WYLE LABORATORIES RESEARCH STAFF
Technical Memorandum 66-21

REVIEW OF PROPOSED CONTROL
AND INSTRUMENT ROOM FOR BUILDING 4776,
MARSHALL SPACE FLIGHT CENTER
HUNTSVILLE, ALABAMA

Figure 1a. Proposed Construction

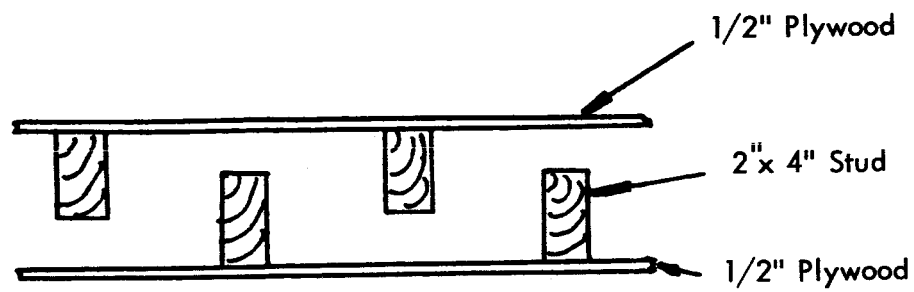
The following description is taken from a sketch provided by R-AERO-AFG, (Reference 2). The proposed room would be constructed with staggered 2 x 4 inch studs with 1/2 inch plywood attached to both sides to produce a double wall construction. See Figure 1a. The inner and outer walls are attached at the top and bottom to a 2 x 6 inch board. A double ceiling is provided, and the construction uses wood and glue. A double window facing the jets is included to allow the facility controller to view the gas flows and instrument rakes etc.

The immediate criticism of the instrument room, must be that the sound absorption features of the proposed construction are not sufficient. The proposed construction contains numerous examples where the double wall technique is jeopardized by direct connection between the inner and outer walls. This will remove the full advantages of this form of sound insulation. It should also be noted that a double floor is not provided.

The double windows, as designed, include 2 x 6 inch members connecting the inner and outer walls. These were included to seal the space between the glass panes to allow control of window misting. However, this does provide a direct path between the two walls. Therefore, it is recommended that the two windows be constructed separately. If any sealing is necessary it could be accomplished using flexible polyethelene sheet.

The proposed ceiling construction also connects the inner and outer room, as does the construction of the door frames. Both of these techniques should be eliminated. The two rooms should be completely separate, except through the connection at the floor. Double doors are not specified, but these are necessary if the full advantages of the double wall construction are to be realized.

Figure 1b. Recommended Construction

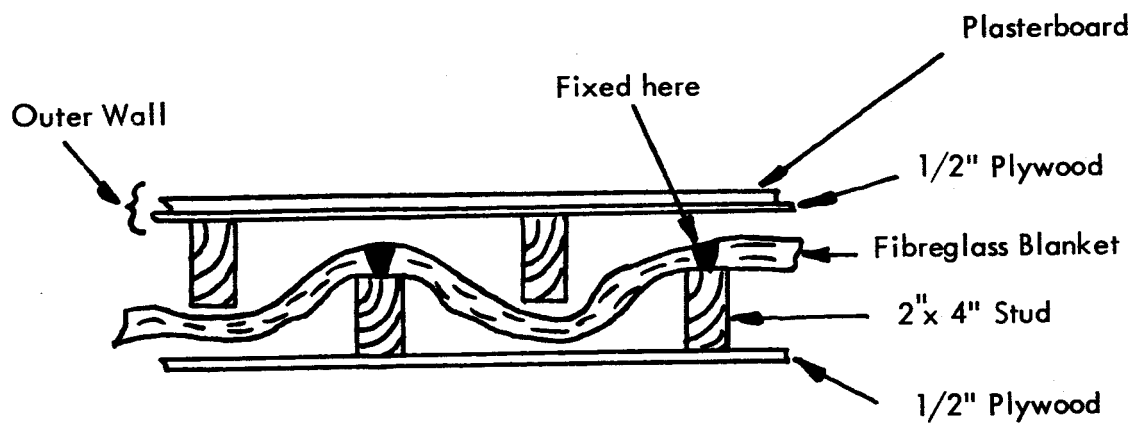
- e) The addition of a fiberglass blanket, of some other sound absorption material, between the two walls will be necessary to provide any reasonable reduction in the noise level. This fiberglass blanket would be tacked on to one wall only, so as not to constrain the movement of the two walls. A sketch shows this addition and the extra plasterboard layer in Figure 1b. Such a construction would be especially advantageous on the wall facing the nozzles.
